End of Addendum No. 1

**Holy Family Cemetery
Crematorium Building
2523 Lower Base Line Road, Milton ON**

ELECTRICAL ADDENDUM #E1

Title: **BOREHOLE LOCATION PLAN**
 File No. 11-13-3165

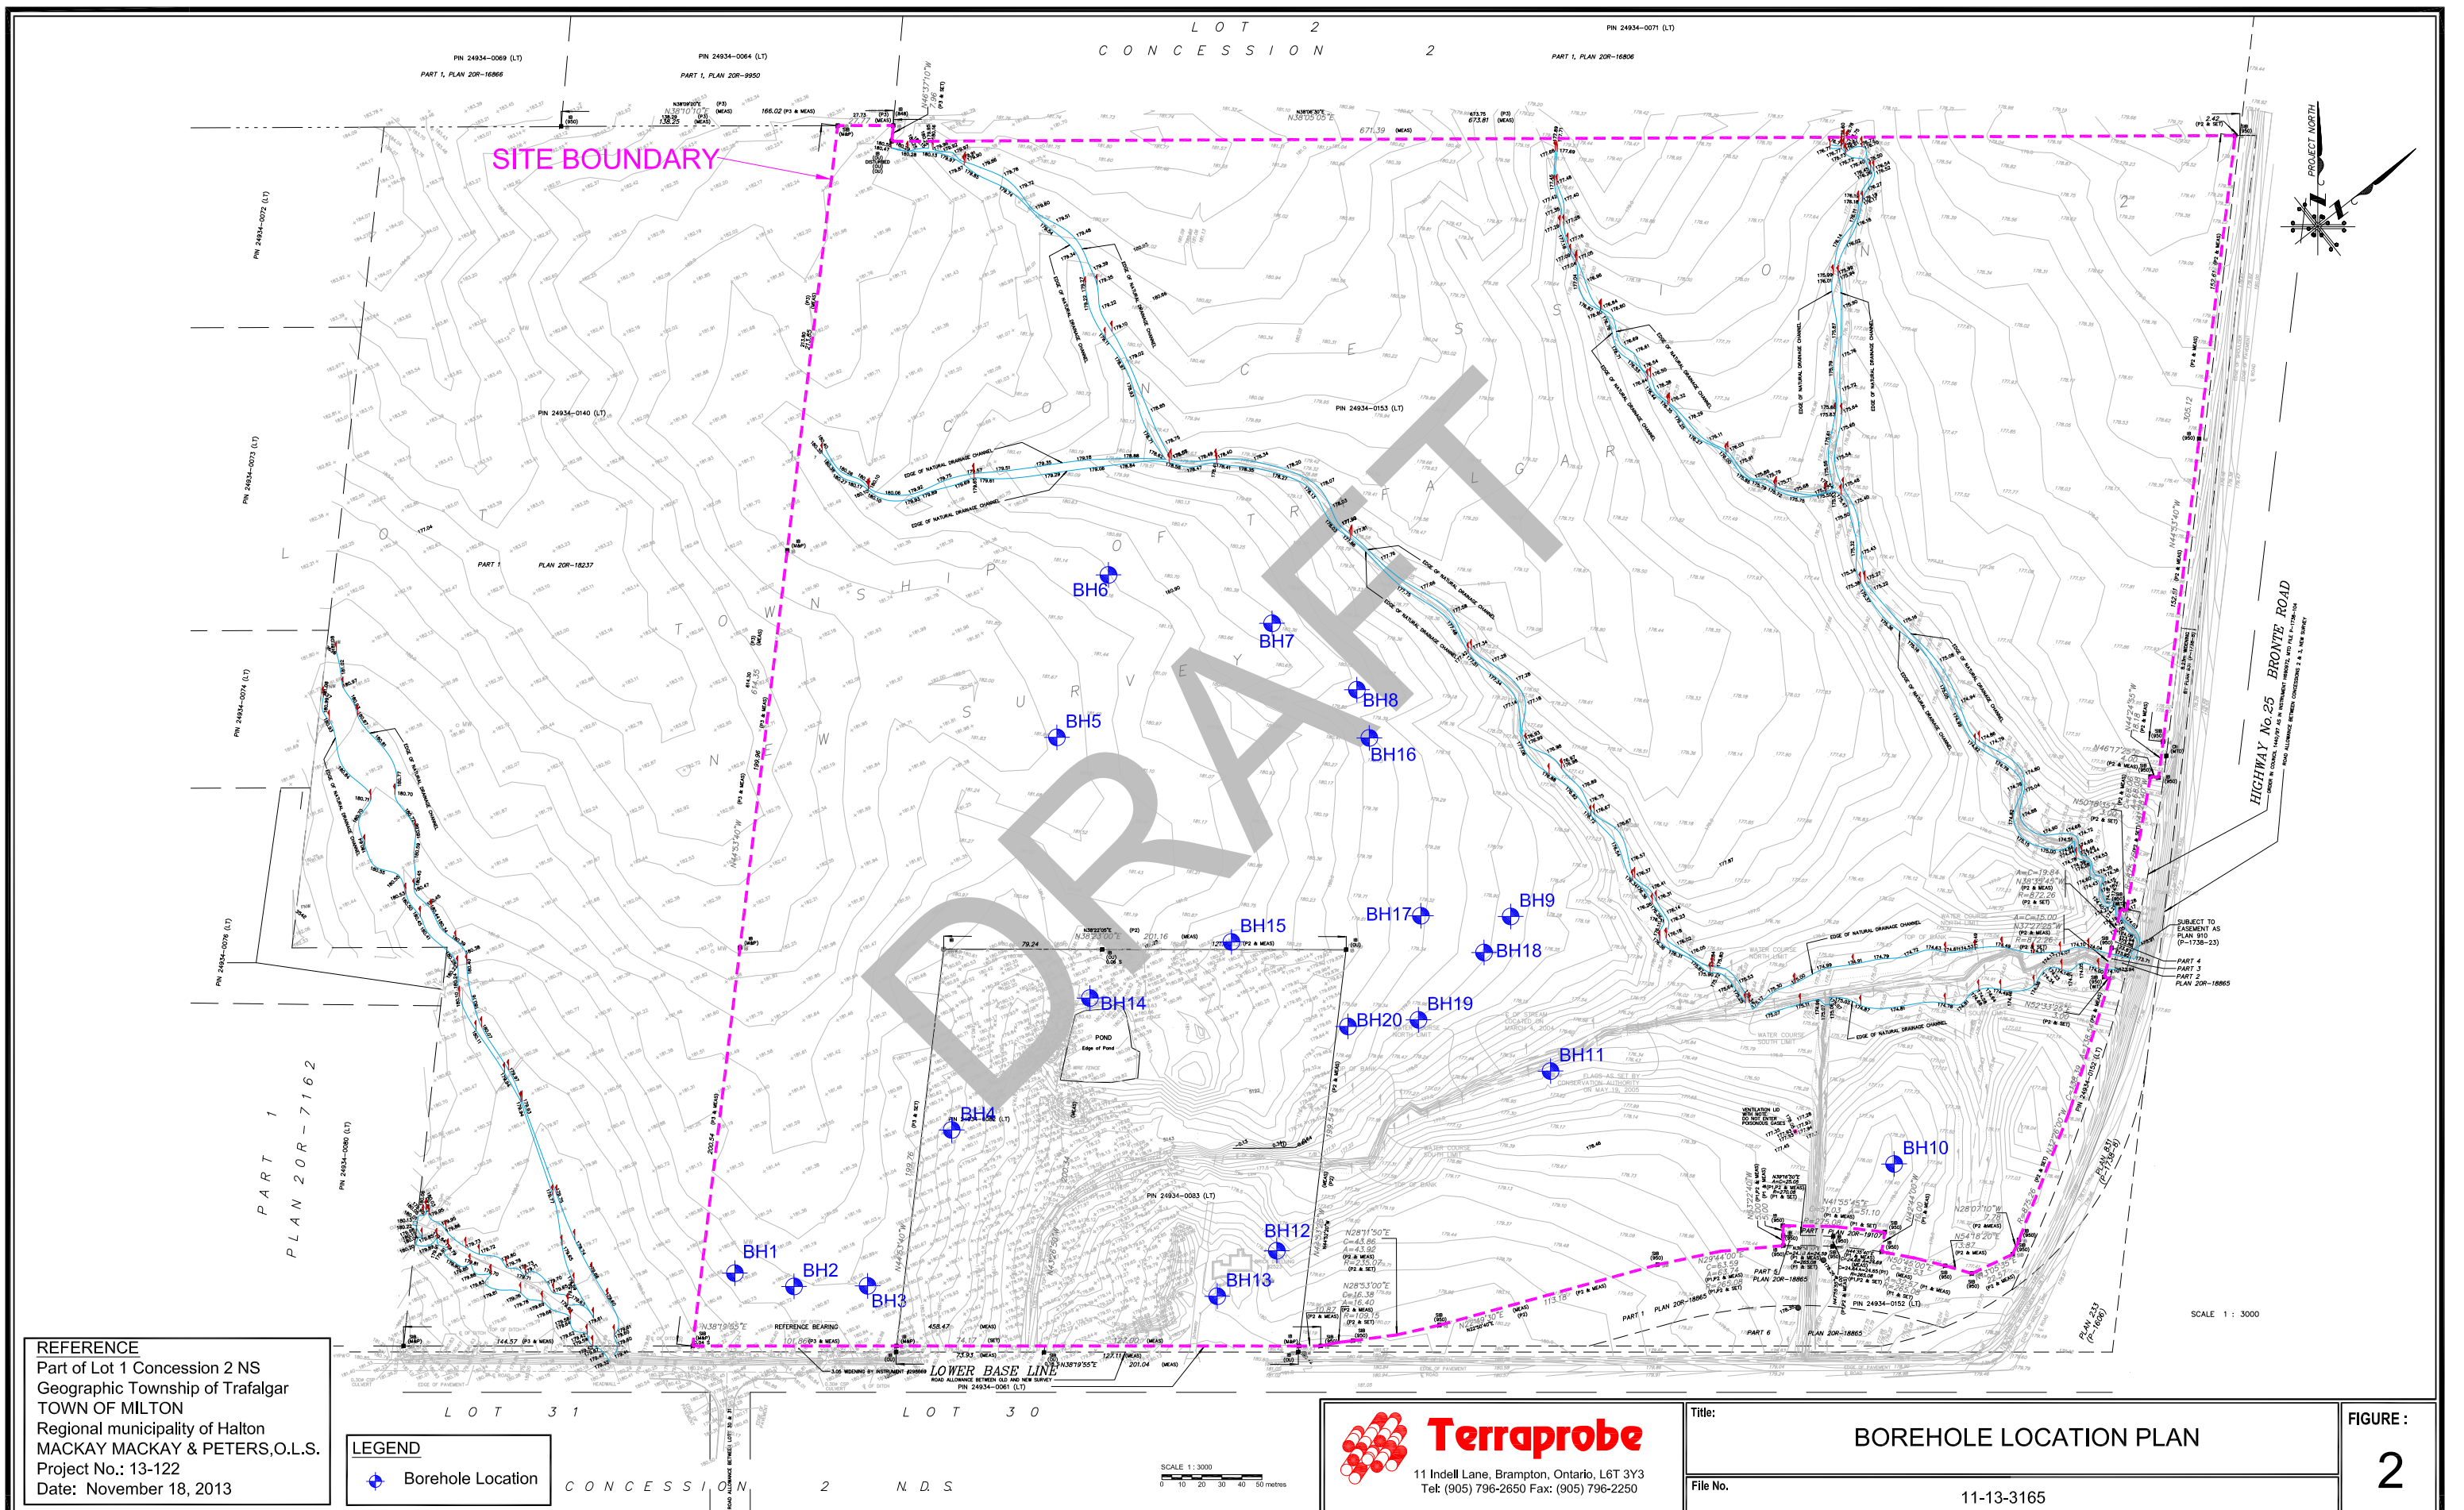
Item 5 Specification Section 00300 Geotechnical Investigation
Add “Borehole Location Plan”

Is it possible to get a map for the exact location of boreholes? Geotechnical report states that boreholes 6 and 10 were drilled within location of a proposed crematorium. Borehole 10 was dry upon completion of drilling, but borehole 6 had water in October 24, 2013 at 2.4m below ground surface,

and in November 12, 2013 at 1.1m below ground surface. Foundation depth is 1.350m. We need to know if borehole 6 is within the building footprint. Also, would you be able to comment on the flow of underground water since foundation of the administrative building was already completed.

Refer to item#5. As per the enlarged site plan (A1.10) and the borehole location plan, BH 6 is located just outside of the southeast corner of the building.

DRAWING TITLE
**ELECTRICAL
 LIGHT STANDARD DETAIL**

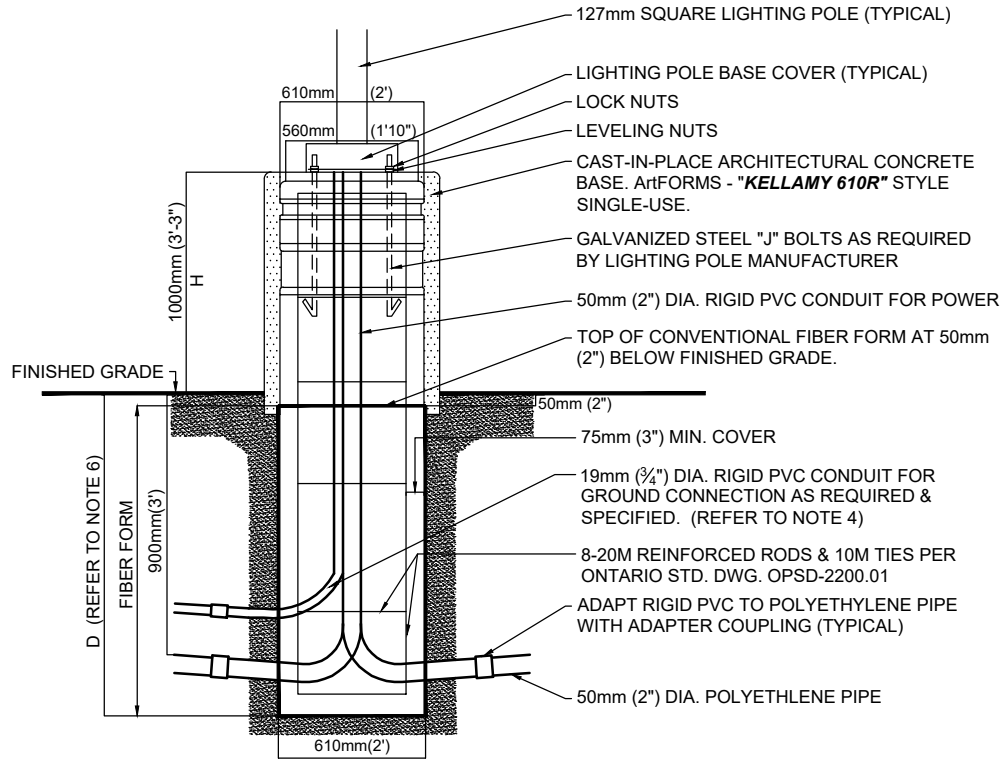
With reference to the new Light Pole bases and Bollards (for lighting) there are no details found in the electrical drawings. Kindly provide these details

Q14. With reference to the new Light Pole bases and Bollards (for lighting) there are no details found in the electrical drawings. Kindly provide these details.

R14. Refer to attached sketch SK-E05-1 for Light Standard Detail. Refer to attached sketch SK-E05-2 for Bollard Base Detail.
